**Re: Case No. 2013-00475, In the Matter of Kentucky Power Company's
Integrated Resource Planning Report**

SIERRA CLUB'S COMMENTS ON KENTUCKY POWER COMPANY'S
INTEGRATED RESOURCE PLANNING REPORT

Figure 2: AEP Rockport Facility

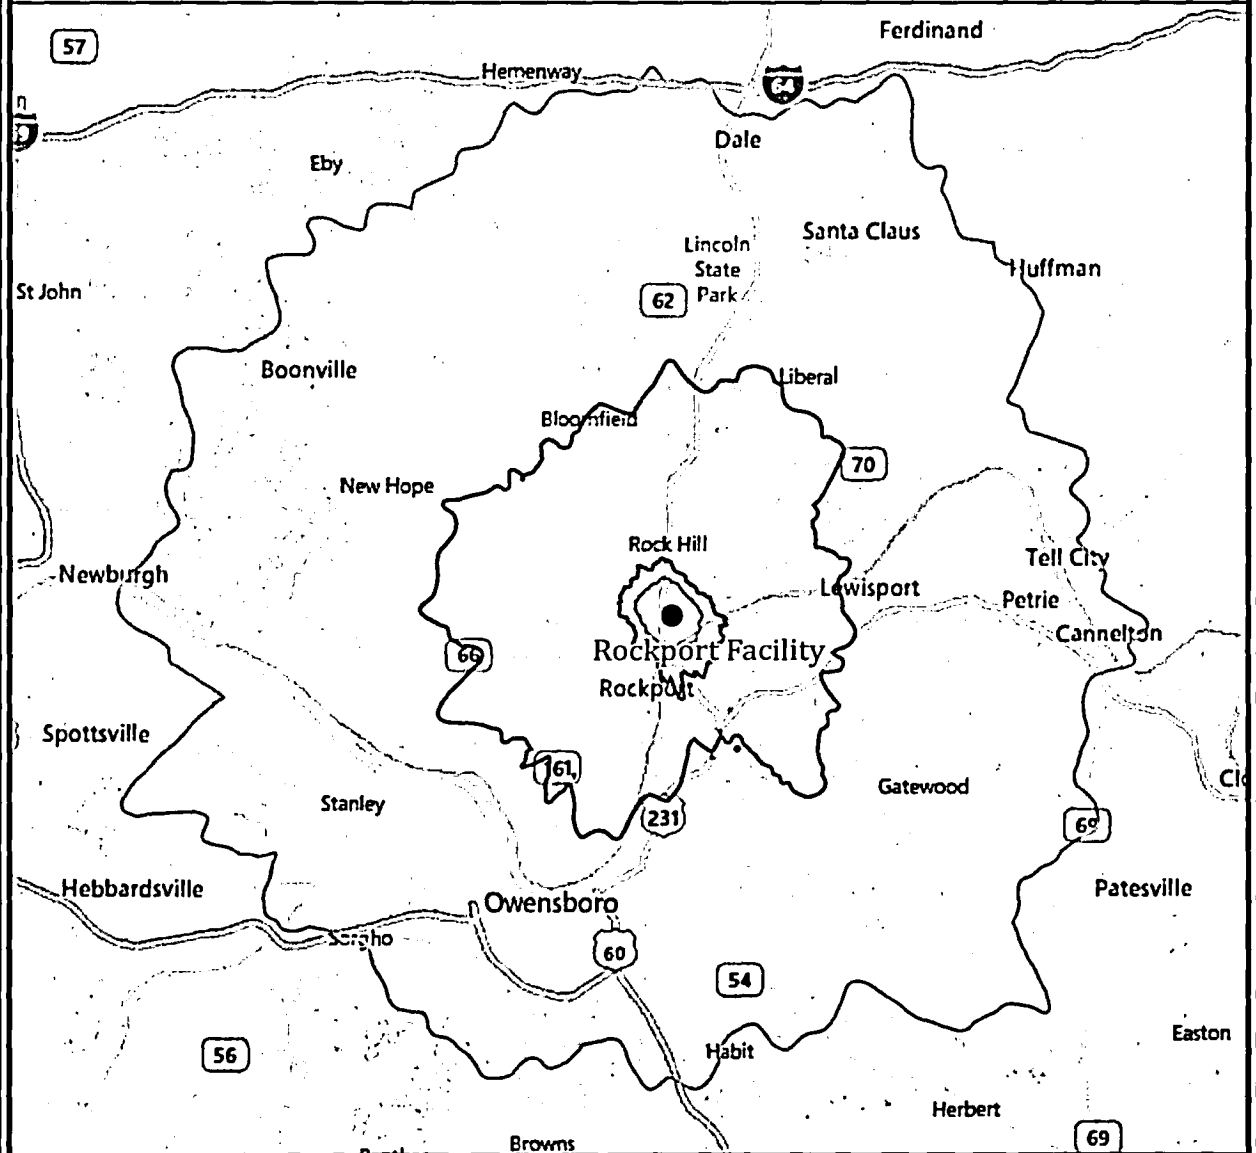
Figure 2 shows modeled one-hour SO₂ concentrations from allowable Rockport emissions, with background values. This map shows two SO₂ concentration levels: 250 and 325 µg/m³. The regions within each isopleth have air concentrations that exceed the levels found on each isopleth. The areas encompassed by these isopleths significantly exceed the 196 µg/m³ one-hour SO₂ NAAQS and could result in a designation of nonattainment for that region. The 196 µg/m³ one-hour SO₂ NAAQS isopleth extends well beyond the region shown on this map, but was not included due to the distance limitations in AERMOD modeling.

Figure 3: AEP Rockport Facility

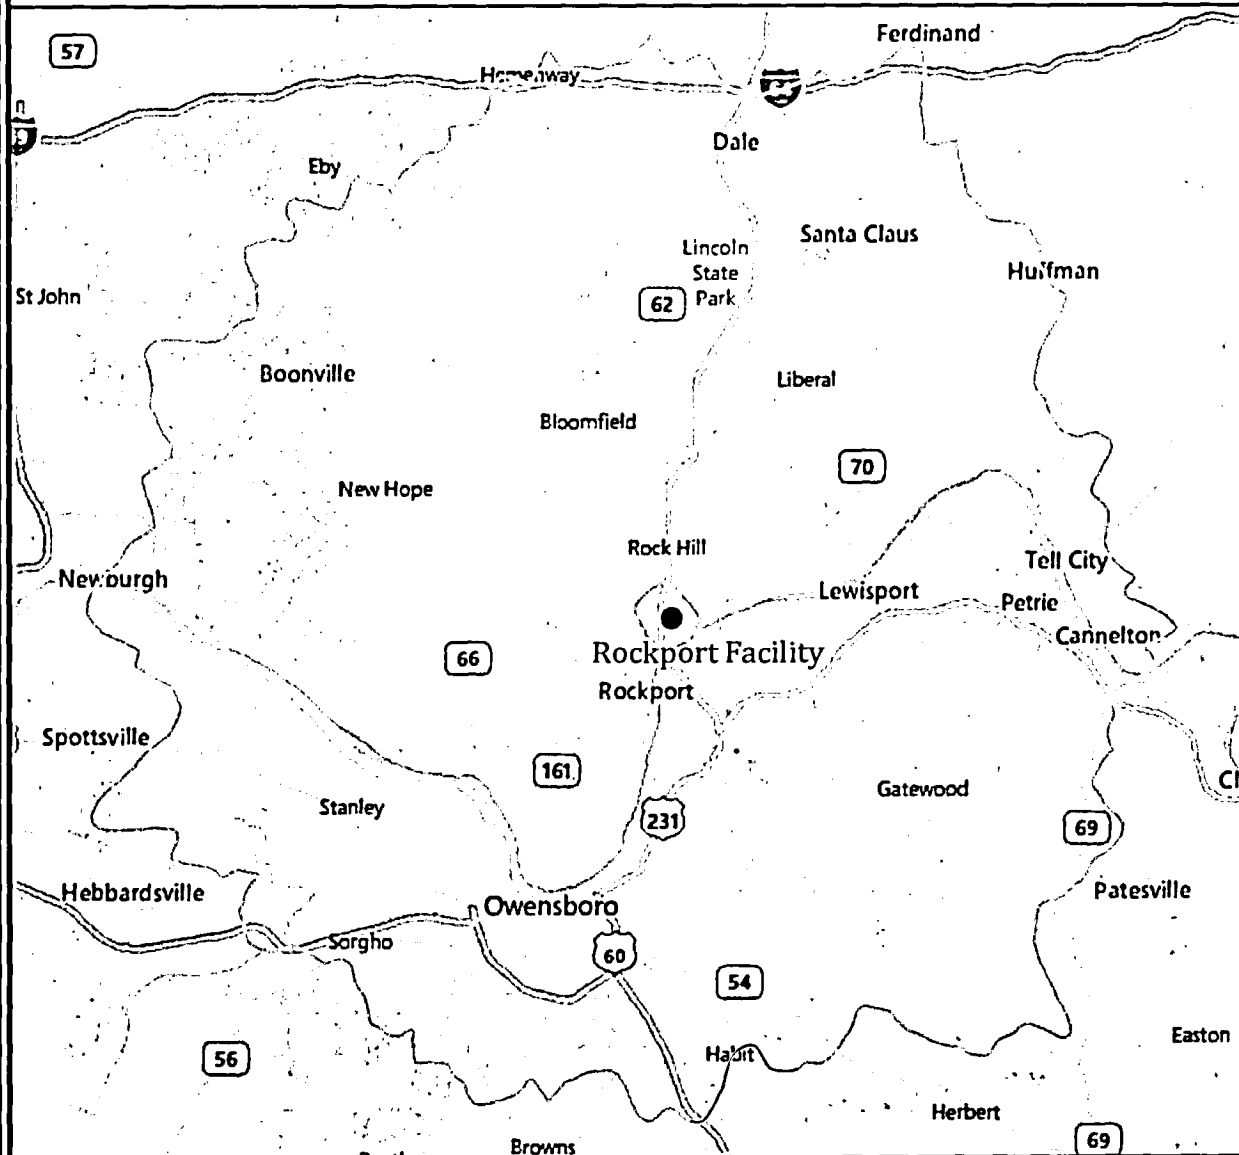
Figure 3 shows modeled one-hour SO₂ concentrations caused by DSI-controlled Rockport emissions (50% reduction), with background concentrations. This map shows one SO₂ concentration level: 196 µg/m³. The area encompassed by this isopleth also exceeds the 196 µg/m³ one-hour SO₂ NAAQS and could result in a designation of nonattainment for that region.
